A meeting of the **ARGYLL AND BUTE LOCAL REVIEW BODY** will be held in the **COUNCIL CHAMBER, KILMORY, LOCHGILPHEAD** on **WEDNESDAY, 23 JANUARY 2013** at **3:50 PM**, which you are requested to attend.

1. **APOLOGIES FOR ABSENCE**
2. **DECLARATIONS OF INTEREST (IF ANY)**
3. **CONSIDER NOTICE OF REVIEW: MACKAY'S GARAGE, LEDAIG, TOBERMORY, ISLE OF MULL, PA75 6NR**
  - (a) Notice of Review and Supporting Documentation (Pages 1 - 14)
  - (b) Comments by Interested Parties
    - i Planning (Pages 15 – 28)
    - ii Roads (Pages 29 – 30)

Demolition of detached store and  
erection of extension to existing  
commercial garage

**REFUSAL OF PLANNING PERMISSION FOR THE  
DEMOLITION OF A DETACHED STORE AND  
ERECTION OF AN EXTENSION TO AN EXISTING  
COMMERCIAL GARAGE**

title: site info  
scale: as noted @ a3  
drawing: **jm/62/001**  
project: extension @ mackays garage

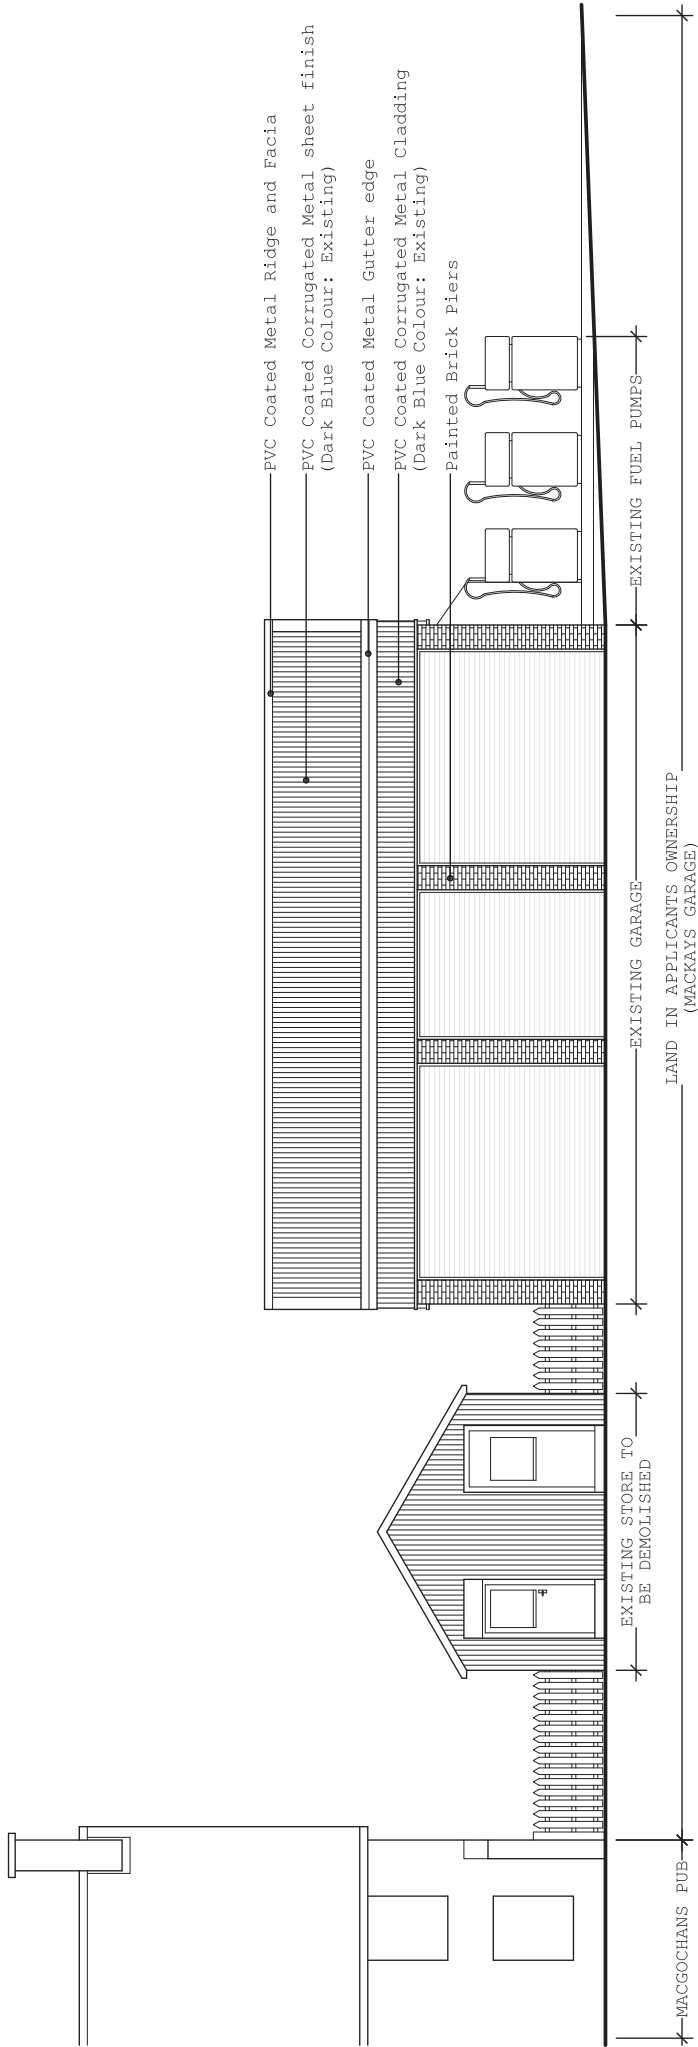
The planning application does not show the off street parking required for the operation of the business. There are three work stations at present and they should have 14 parking spaces for vehicles (4 spaces per work station plus 1 space per two employees). In addition, spaces are also required for recovery vehicles and car sales. The increase to four work stations would increase the number of spaces to a minimum of 18 plus recovery and sales.

This application should be refused until the applicant can show the relevant number of parking spaces within his own land.
